## XC2300E Derivatives

Errata Sheet

V1.2 2013-07

**Figure 1    Critical application reset sequence**

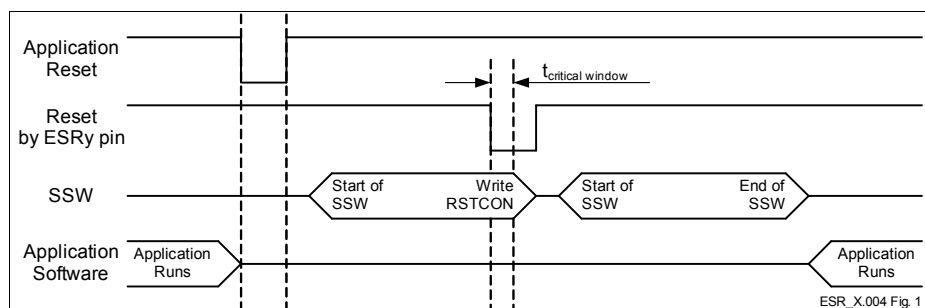
### **ESR\_X.004    Wrong Value of SCU\_RSTCONx Registers after ESRy Application Reset**

SCU\_RSTCONx registers are reset only by Power-On, but they may be wrongly affected after a second application reset requested by an ESRy pin. This may lead to the SCU\_RSTCONx register values being set to zero, which could unexpectedly disable reset sources within the user application. The conditions which lead to this behavior are:

1. First, an application reset by SW (software), CPU (Central Processing Unit), MP (Memory), WDT (Watchdog Timer) or ESRy (External Service Request y) occurs.
2. Following this, an application reset on an ESRy pin occurs.
3. If the above mentioned ESRy reset occurs during a critical time window of the SSW (startup software), then it's possible that the application will operate with the wrong SCU\_RSTCONx register value. The critical time window occurs when the SSW is writing the SCU\_RSTCONx registers, and at the same time, the ESRy reset request is processed by the reset circuitry. The width of this critical window  $t_{critical\ window}$  is less than 13 cycles.

- Initialize `SCU_RSTCONx` registers by user software after any reset, or
- assure that a second application reset request with an ESR pin does not occur during the critical time window.

**Figure 2** Example for a Slow Input Signal

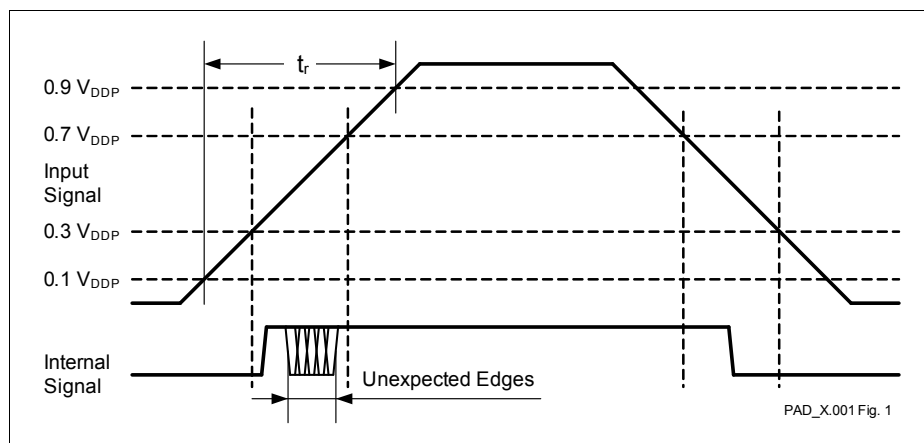
The digital input- and I/O-pins are designed using Schmitt trigger input structures with hysteresis. Even with this structure, it is possible that very slow rising edges may generate spikes, resulting in unexpected additional edges at the input signal.

The next picture **Figure 2** is an example for a slow input signal, with spikes shown on the slow rising input signal.

The first rising edge in **Figure 2** of the internal signal is always valid. The edges which are marked with “Unexpected Edges” must be ignored.

**Figure 3 Falling Edge Detection Approach**

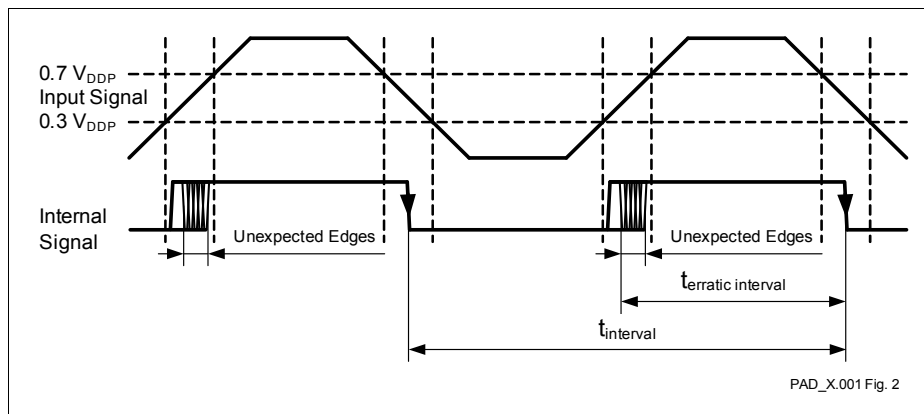
1. Measure the time interval since the last interrupt (shown as in  $t_{\text{interval}}$  in [Figure 3](#) below) and check that it is in the expected time range.  
In the example, an erratic edge would cause the measured time interval  $t_{\text{erratic interval}}$  to be approximately 50% of the expected value.
2. The state of the input pin that caused the interrupt could be read several times in the interrupt service routine and a majority decision made to check if the input pin really is at a low level to determine whether this is a genuine falling edge interrupt or whether the interrupt was triggered by a spike generated by a slow rising edge.

Only if 1) and/or 2) indicate that the edge was reliable, should the rest of the interrupt service routine be executed.

**Figure 4 Rising Edge Detection Approach**

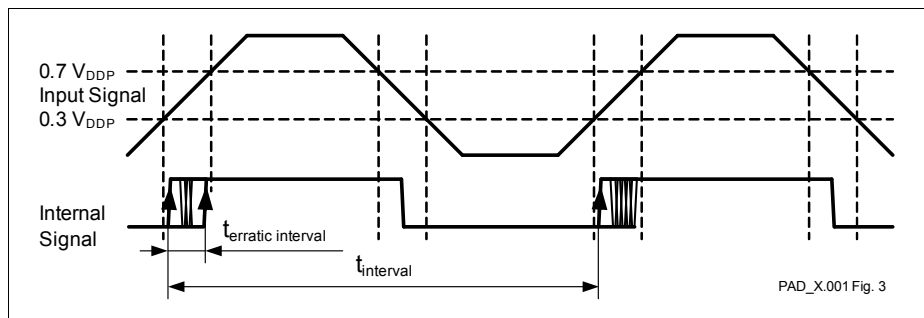
In case of rising edge detection multiple interrupts would be generated when the spike occurs. The time interval since the last interrupt can be measured – if it is very small compared to the expected value, this would indicate a spike and the interrupt should be ignored.

If the time between the rising signal edge and the rising edge caused by a spike  $t_{erratic}$  is less than the ISR service time, a workaround would be to clear the

**Figure 5 Rising Edge and Falling Edge Detection Approach**

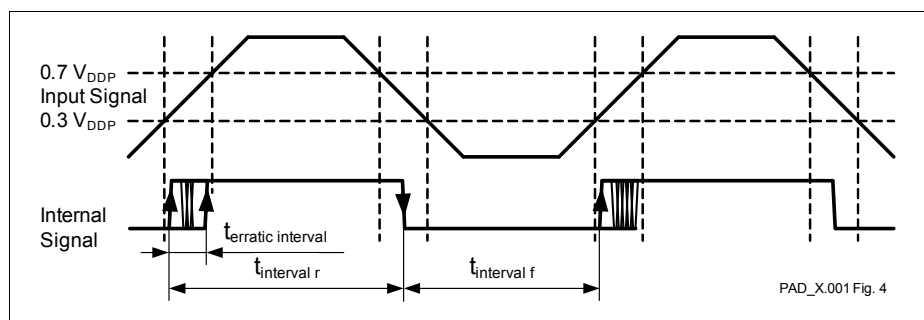
The rising edge detection workaround works also if both edges are used as trigger for interrupt and the following conditions are valid:

- $t_{\text{erratic interval}} \ll t_{\text{interval r}}$  and
- $t_{\text{erratic interval}} \ll t_{\text{interval f}}$

**Figure 6 Alert Interrupt Behavior in case of Bus-Off**

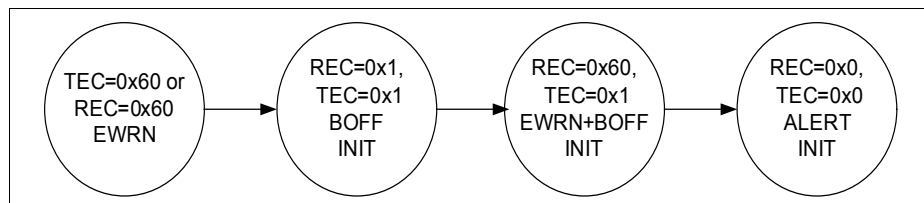
### **MultiCAN\_AI.H007 Alert Interrupt Behavior in case of Bus-Off**

The MultiCAN module shows the following behavior in case of a bus-off status:

**Figure 7 Loss of Arbitration**

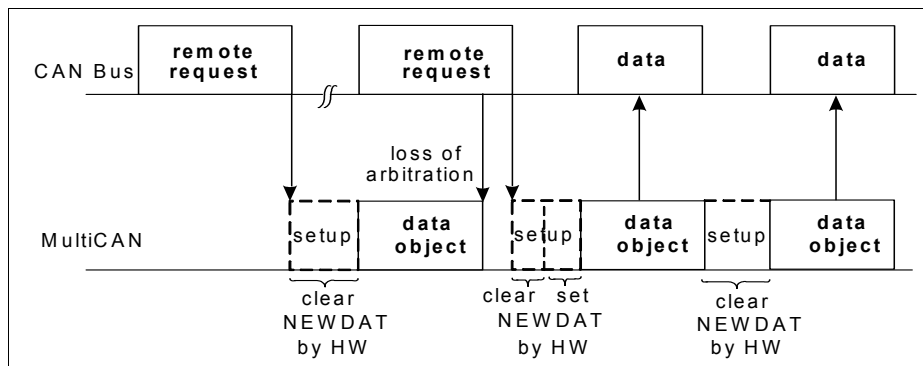
When the appropriate message object (data frame) triggered by the first remote frame wins the arbitration, it will be sent out and `NEWDAT` is not reset. This leads to an additional data frame, that will be sent by this message object (clearing `NEWDAT`).

There will, however, not be more data frames than there are corresponding remote requests.
